Re: SOAH Docket No. 582-22-0844.TCEQ; Texas Commission on Environmental Quality No. 2021-1000-MSW; *Application by Diamond Back Recycling and Sanitary Landfill, LP for Municipal Solid Waste Permit No. 2402*

**PROPOSAL FOR DECISION**

Figure 1 – Application Figure III.C2.1 showing the drainage areas, Comparison Points, and North and South Ponds

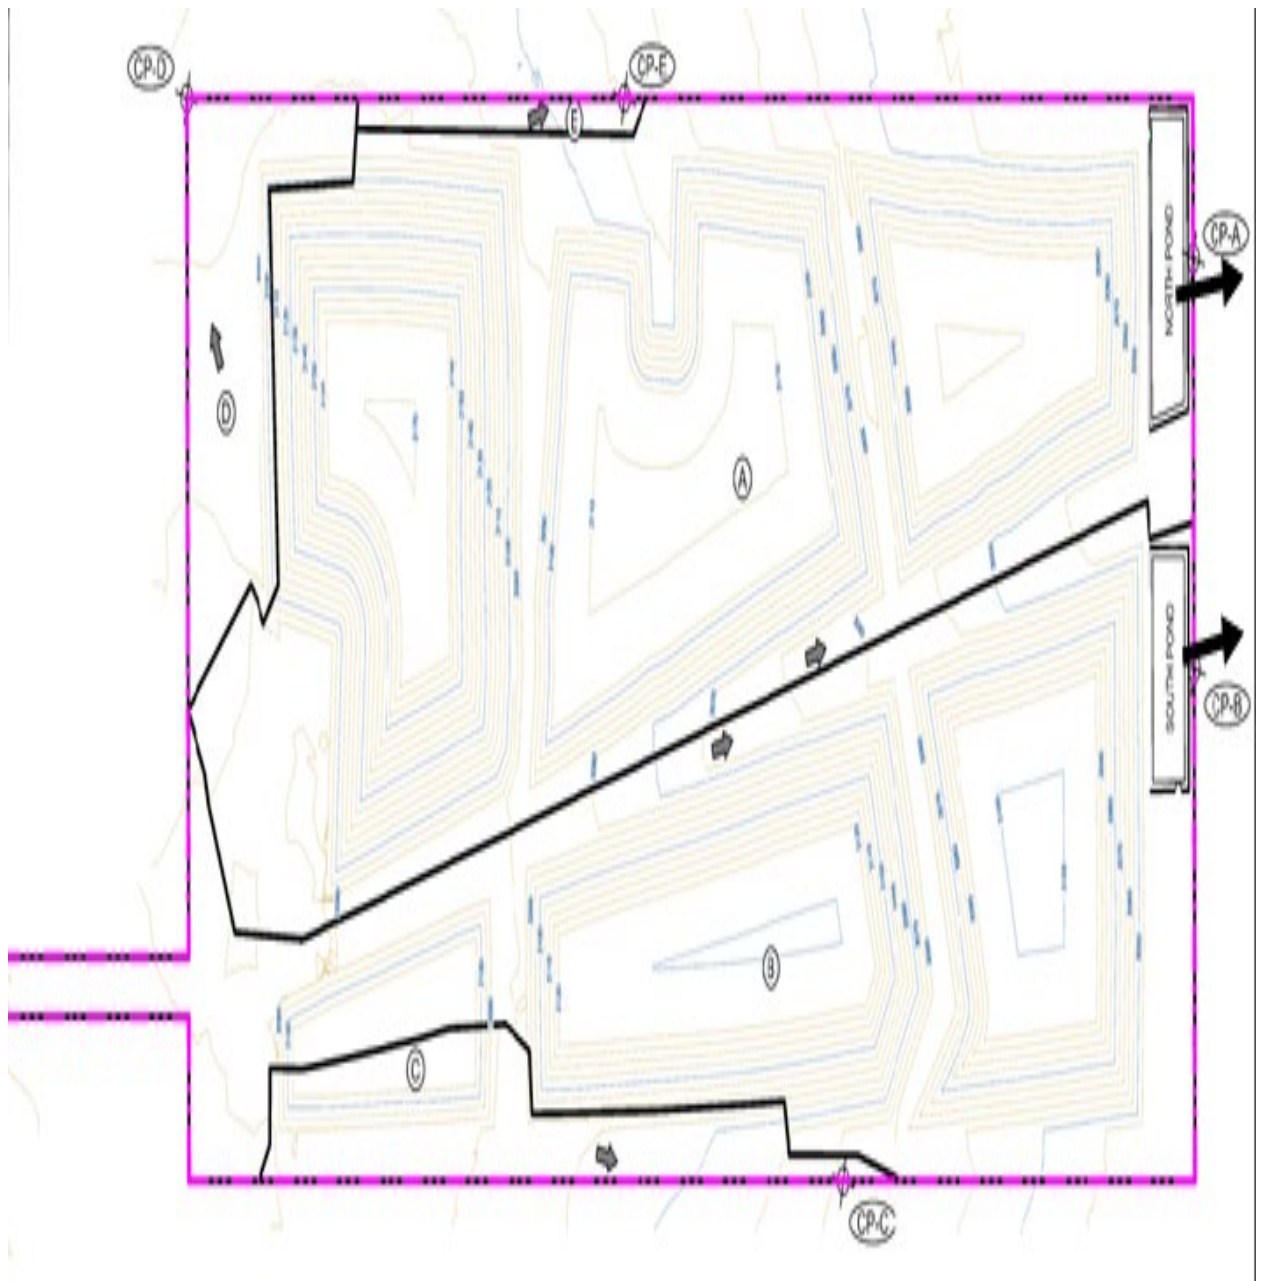
Attachment C, Part III of the Application addresses the requirements for assessment of drainage patterns. Applicant used a “modified rational method” to calculate the volume of storage needed to mitigate surface water drainage from pre-development to post-development conditions.<sup>68</sup> The water exits the site, for the most part, along its eastern perimeter. The parties agree that under existing conditions, surface water runs off the site via overland flow, exiting the site in a diffuse manner rather than a channelized flow or defined discharge route.<sup>69</sup>

detention ponds, where it will be discharged at the permit boundary over weirs (barriers across the width of the pond to help control the flow of water).<sup>70</sup>

The preponderant evidence demonstrates that Applicant failed to provide a sufficient surface water drainage report. Given the ED's preliminary decision to issue a Draft Permit, the ALJ must conclude that the ED approved Applicant's use of a modified rational method for the calculation of drainage characteristics. Nonetheless, the ALJ is persuaded by Mr. Dunbar's testimony that Applicant overestimated existing runoff velocity and peak flow by making assumptions that do not accurately reflect on-site conditions. Therefore, the ALJ concludes that the peak flow for existing conditions has been overestimated by Applicant.

The ALJ also concludes that Applicant's detention/retention pond sizing is underestimated. Importantly, Applicant's expert, Mr. Stiggins, admitted during the hearing that he did not use a 25-year/24-hour storm for his analysis required by the TCEQ Rules. This inaccurate analysis could result in water drainage at a peak flow higher than Applicant predicts, adversely altering drainage patterns. Further, while the ED found the Application administratively and technically complete, Mr. Yadav testified that he did not independently verify Applicant's design or calculations; he relied on the fact that the drainage report is sealed by a professional engineer.
